IEEE 802.1AS REV D5.0 Review Comments

doc.: IEEE P802.11-17-1086r3

Proposed Solution-A

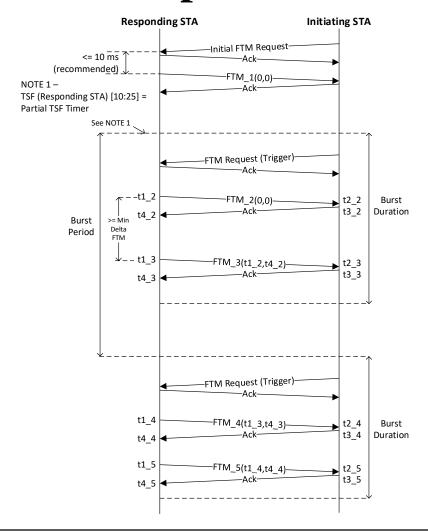
• Amend 802.1AS REV D5.0 to use multiple burst instead of single burst

Each burst has up to 32 FTM frames

Issues

- Still does not allow for "infinite" number of FTM frames to be sent; as the maximum number of bursts is limited to 2^{15}
- May cause discontinuity in the flow of time information from the top of the network to the leaf
 - This is because all burst excepting the first one needs to be started with a FTM Request frame from the Slave to the Master
 - This discontinuity may not be an issue if the slave transmits the FTM Request to trigger a new burst in a timely manner

Proposed Solution-B

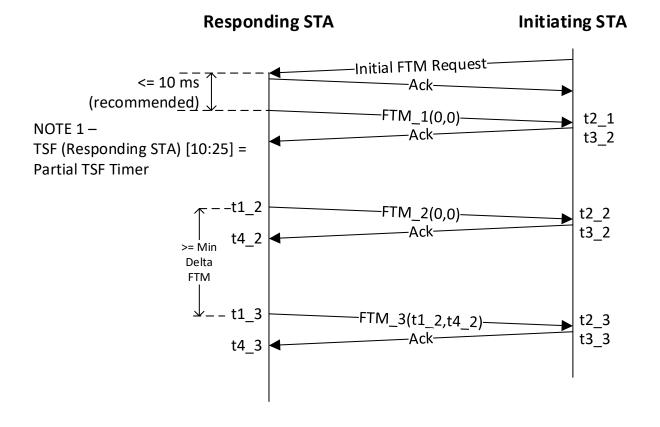
- Amend IEEE 802.11-2016 to allow for a new choice for the number of FTMs per Burst
 - Use one of the reserved values from the possible values for Burst Duration (values 12-14 are reserved in IEEE 802.11-2016)
 - Initiator sets FTMs per burst to 0 (indicating no preference) and sets Burst Exponent to 0 (Single Burst)
 - Responder sets Burst Duration to 12 (indicating "Forever") and sets Burst Exponent to 0 (Single Burst)
 - Responder sets FTMs per Burst to 0 (currently disallowed in IEEE 802.11-2016) indicating "infinite" FTMs (new behavior)
- How does one enable both Location Services and 802.1AS between two peers?
 - Only one FTM Session can exist at any one time between two peers.
